Planning and Zoning Commission

Oak Bend Subdivision Phase I

Preliminary Plat

September 12, 2024

**PRELIMINARY PLAT ESTABLISHING
OAK BEND SUBDIVISION PHASE I**

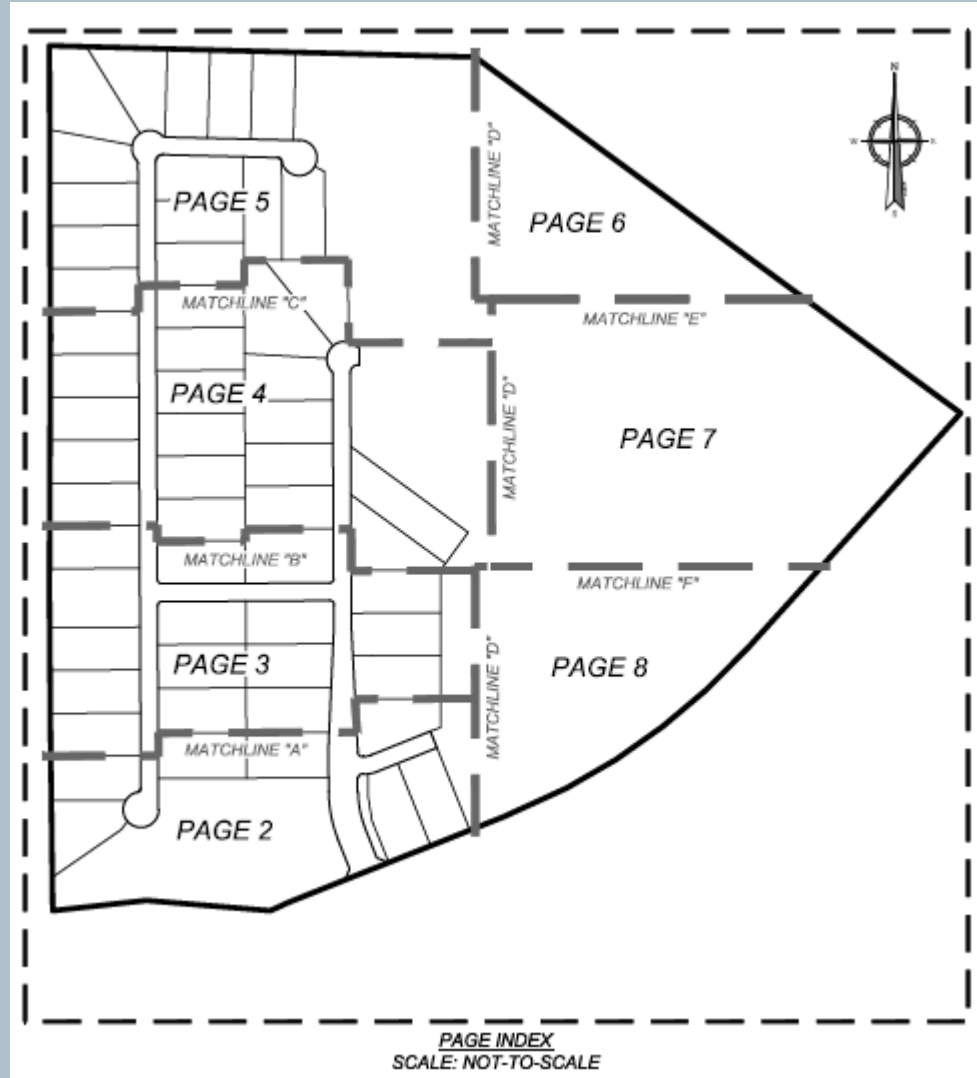
1. Confirm how the proposed development will comply with Article II Section 3, Submission of Final Plat of Subdivision Regulations.
2. Show that the street Bald Cypress Court will be connected to the adjoining street on the east in Phase II in the future and add a plat note regarding this.
3. Remove building setback legend from the “existing keynotes” (previously titled as “key notes”) on all pages. All setback requirements need to meet the zoning requirements of Neighborhood Residential (NR) District.

3. Provide metes and bounds description to verify all coordinate points on plat. The coordinates and distances indicated in the metes and description in the warranty deed do not match the coordinates and distances called out on the plat.
4. Add a plat note "approval of this plat vacates the approved and recorded Oak Bend Estates Plat."
5. City Council approval of the variance (PV-2024-01) for thirty-eight (38) lots that do not meet the minimum 150-foot street lot frontages.
